APPENDIX D

Response to Comments on Draft License Application

On September 28, 2010, PCWA filed its Draft Application for New License with the Federal Energy Regulatory Commission (FERC or Commission) and requested comments from interested parties prior to the comment period closing date of December 27, 2010. The following comment letters were received:

GRAY EAGLE BAR SIDE CHANNEL OBSERVATIONS (CONTINUED)

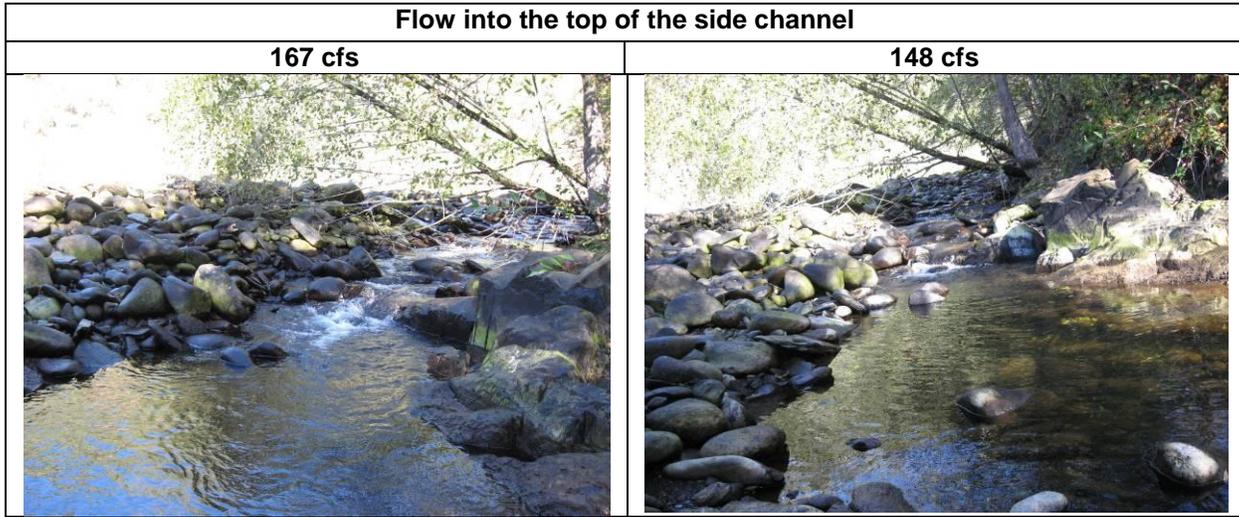
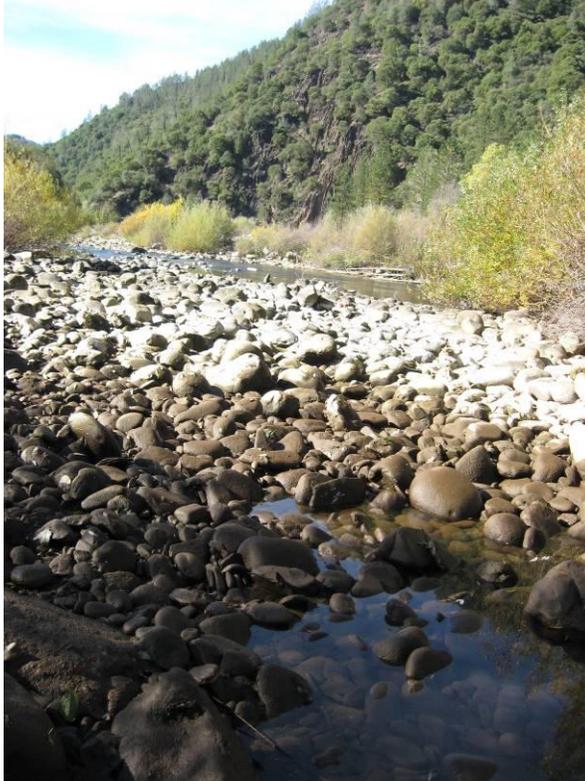
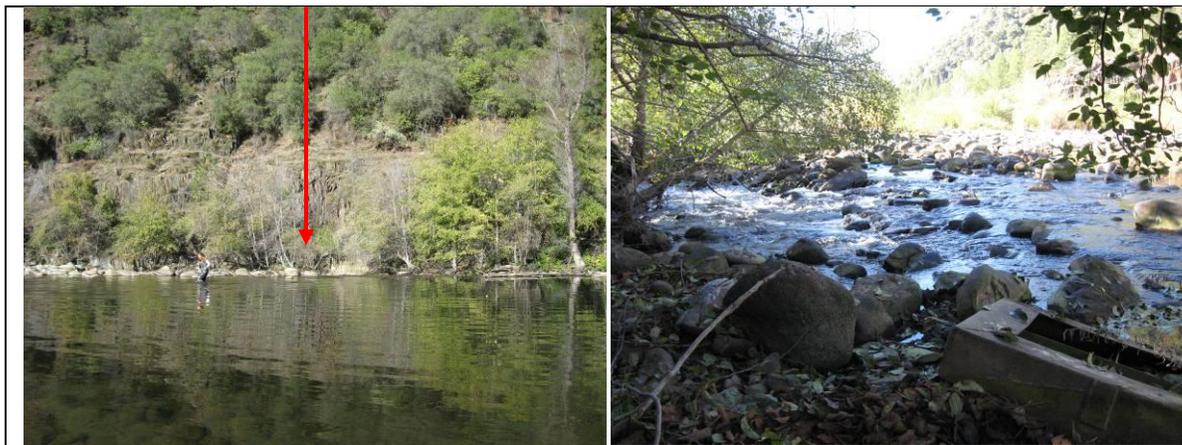
Below are photos of habitat conditions in the side channel at 167 cfs and 148 cfs (11/17/08 and 11/14/08, respectively) in the MFA main channel.

Long riffle habitat in the mid-section of the side channel	
167 cfs	148 cfs

Looking downstream at the last pool in the side channel disconnected from main channel

Figure O-15. Middle Fork American River MF14.1 Effective Food Production Habitat Matrix.

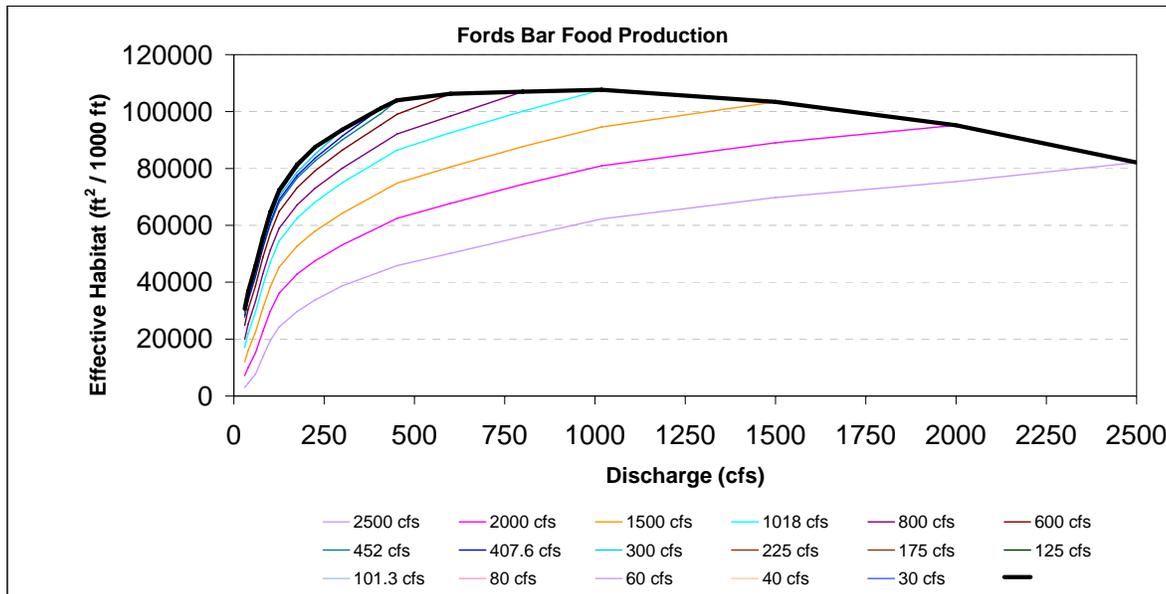
The Foothills Water Network recommends that PCWA include conditions in its FLA that reduce flow fluctuations in the Peaking Reach to increase benthic macroinvertebrates (BMI) populations and food production for fish. Based on PCWA's Effective Food Habitat Matrices for the Peaking Reach, food production increases as the magnitude of flow fluctuations decrease.¹⁰ (See Appendix C for AQ1-Instream Flow Study Report, Figure O-15 and O-24 Middle Fork American Effective Food Habitat Matrices.) An increase in minimum instream flows from the PCWA DLA proposed minimum flows would increase food production and BMI habitat in the Peaking Reach.

Appendix D: Figure 8.52a and 8.52b Average Flow Fluctuations in the Peaking Reach for the Proposed Action and No-Action Alternatives

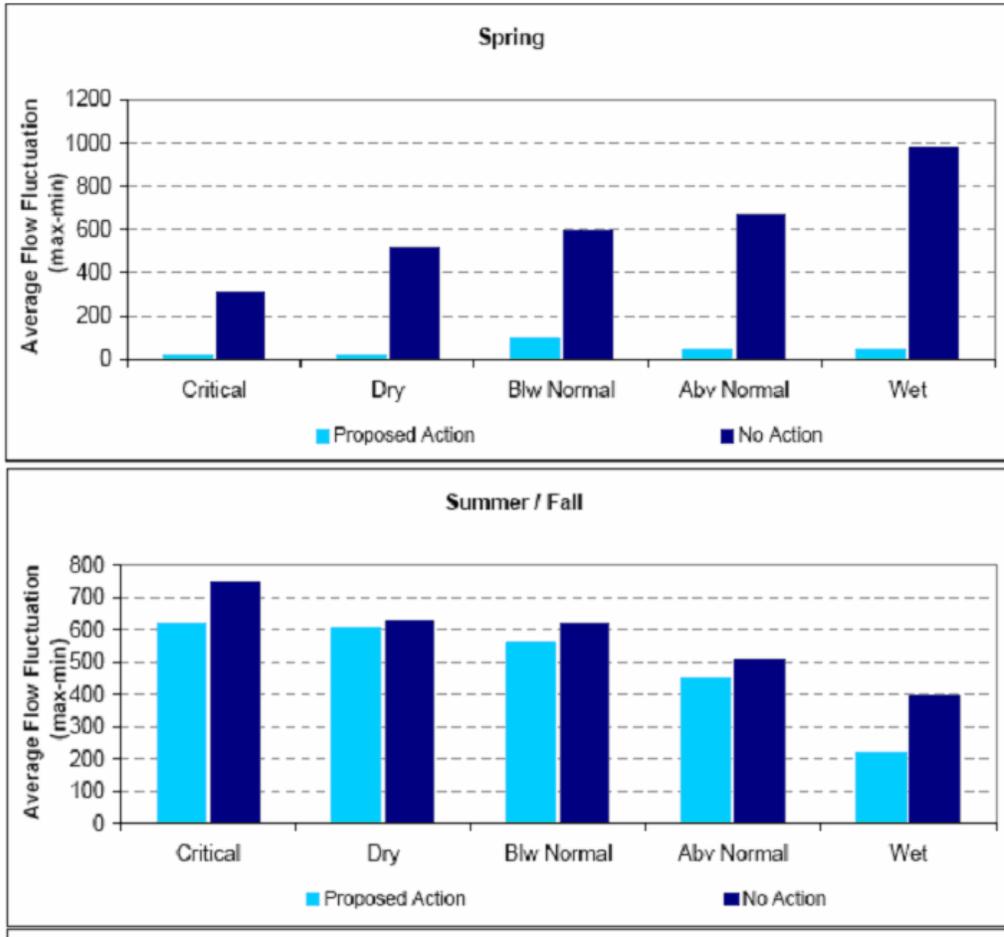
The Network requests that in its FLA PCWA use a more precise metric to compare the decrease in flow fluctuations in the Proposed Action to No Action in addition to the average-based metric used in the DLA.²⁴ (See Appendix D: Figure 8.52a and 8.52b Average Flow Fluctuations in the Peaking Reach for the Proposed Action and No-Action Alternatives). PCWA's methodology of averaging the flow fluctuation differential between the Proposed Action and No Action alternatives fails to measure the effect of the proposed maximum *daily* flow fluctuations. As PCWA's DLA states,

Figure REC 4-7. Example of Project Modification of Flows in the Peaking Reach (Mean Daily Flows).

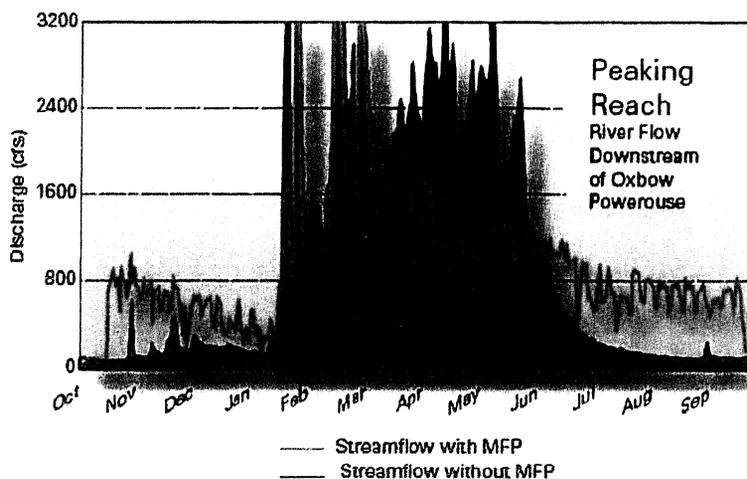
The generalized figure below depicts the disparity between the wide, daily fluctuations of project flows, during mid June to mid October and the much lower, more consistent flows that would occur if the river was not controlled by the hydropower Project. In some water years, a few crossing *opportunities* occur when winter and spring runoff is held back behind the dams. However, during the peak season, project flows prevent trail crossings on a daily basis. Thus crossings, during the peak season, result not so much as an 'opportunity' of the project but as a default of Project operations when baseline low flows occur.

When the low baseline flows occur, crossings are simply not completely impeded. The Proposed Action will further reduce and impede trail connectivity during the primary recreation season in ASRA.

FIG. 3—Depth and velocity limits for safe wading (redrawn from Cortell and Associates, 1977, figure 10). A. Tall, heavy adults. B. Average adults to teenagers. C. Sub-teen children. D. Pre-school children.

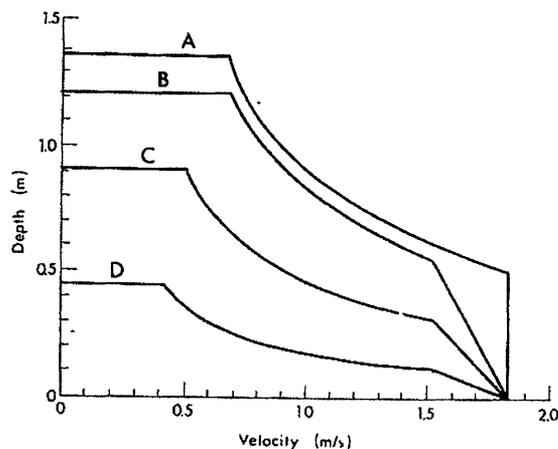
The information obtained from individuals that have many, many years of experience with actual river conditions and crossing possibilities, the Trail Focus Group, falls on Mosley's *sub-teen children* (C) curve, licensee's easy to moderate curve (Figure REC 4-4). The use of the high crossing flow is not applicable, it contradicts the Focus Group information and it does not take into account the other physical features encountered in this river that have a direct effect on crossing possibilities for the average recreationist in the area.
